Entergy
Operations

W3F192-0020
A4.05
QA

April 24, 1992

Subject: Waterford 3 SES
Docket No. 50-382
License No. NPF-38
Technical Specification Change Request NPF-38-123

Figure 1

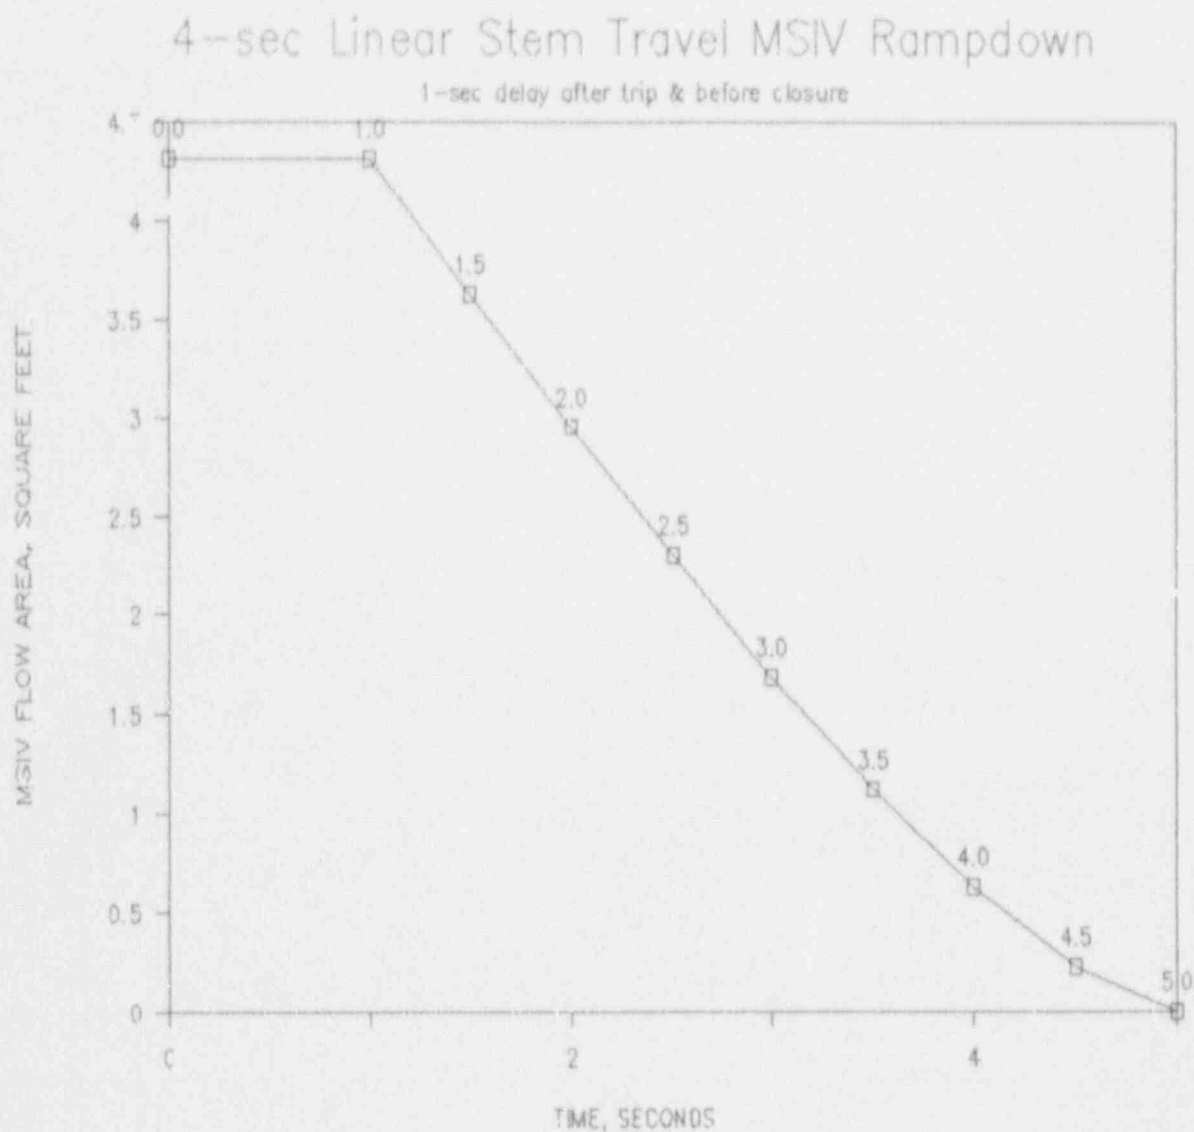
ABB/CE has reanalyzed the mass and energy released to containment for the three most limiting, in terms of peak containment temperature and pressure, MSLB cases with a longer (four seconds)

MSIV closure time. These analyses use a more detailed representation of the steam line piping and pressure drop from SG to MSIV. In addition, more realistic MSIV closure characteristics were used. Instead of an instantaneous closure, the MSIV flow area was decreased as shown in Figure 1.

Illustration of the MSIV Linear Stem Stroke Rate Closure
